Project:
ASSINIBOINE PARK ZOO ASIATIC LION PAVILION
WINNIPEG, MANITOBA

Drawing Title:
FLOOR PLANS
MECHANICAL

Issued For: ADDENDUM NO.3

M1

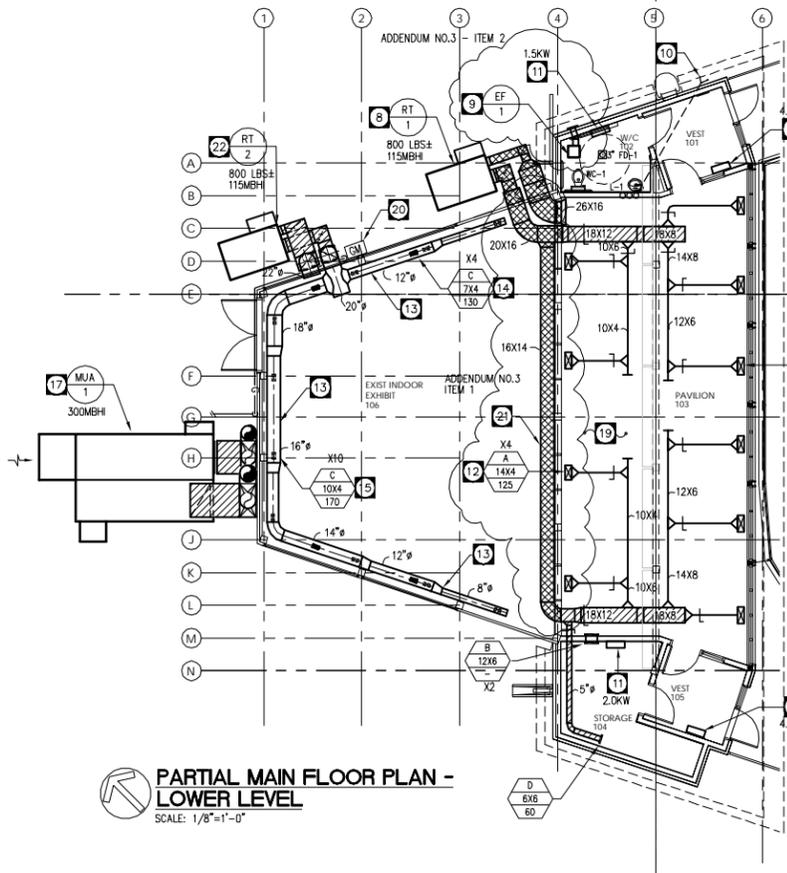
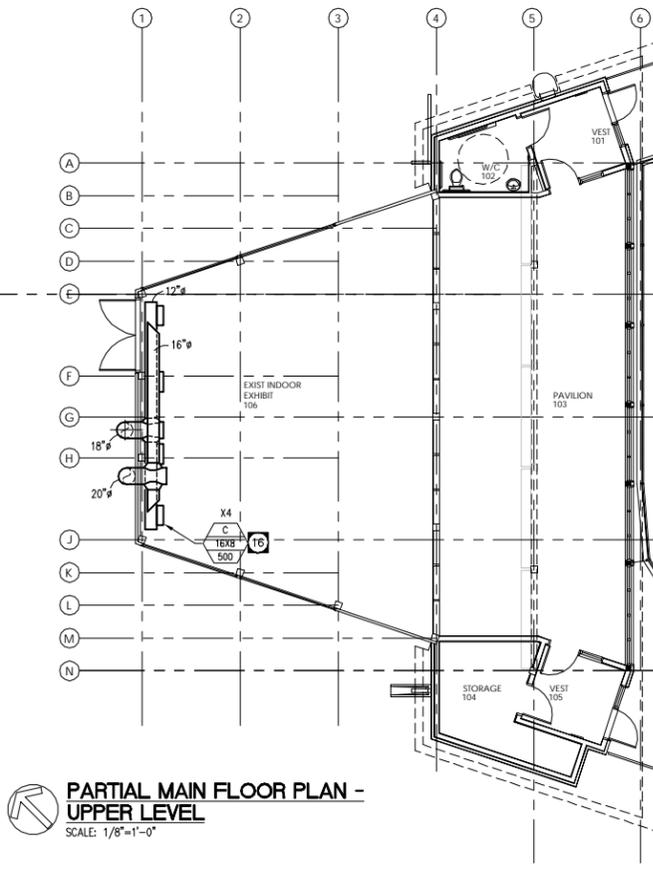
ADDENDUM NO.3
ITEM 1
1. STAINLESS STEEL DUCT SERVING RT-1 WITHIN INDOOR EXHIBIT AREA SHALL BE INSTALLED IN LENGTHS AS REQUIRED TO ACCOMMODATE INSTALLATION OF INTERNAL INSULATION. EQUIVALENT SIZE ROUND DUCTS SHALL BE ACCEPTED PROVIDED ALL AREAS ARE INTERNALLY INSULATED AS REQUIRED. CONNECTIONS AT EACH JOINT SHALL BE MADE VIA MANUFACTURED STAINLESS STEEL DUCT CONNECTION SYSTEM, FLANGED AND GASKETED TO MAINTAIN A WATER TIGHT SEAL. THE GASKET MATERIAL SHALL BE NON-HARDENING, WATER AND MILDEW RESISTANT, AND MEETS APPROVAL OF UL DUCT CONNECTION SYSTEMS AS MANUFACTURED BY DUCTMATE AND NEXUS SHALL BE ACCEPTED, OR APPROVED EQUALS IN ACCORDANCE WITH B-6 INSTALLATIONS TO SMACNA AND MANUFACTURERS RECOMMENDATIONS.
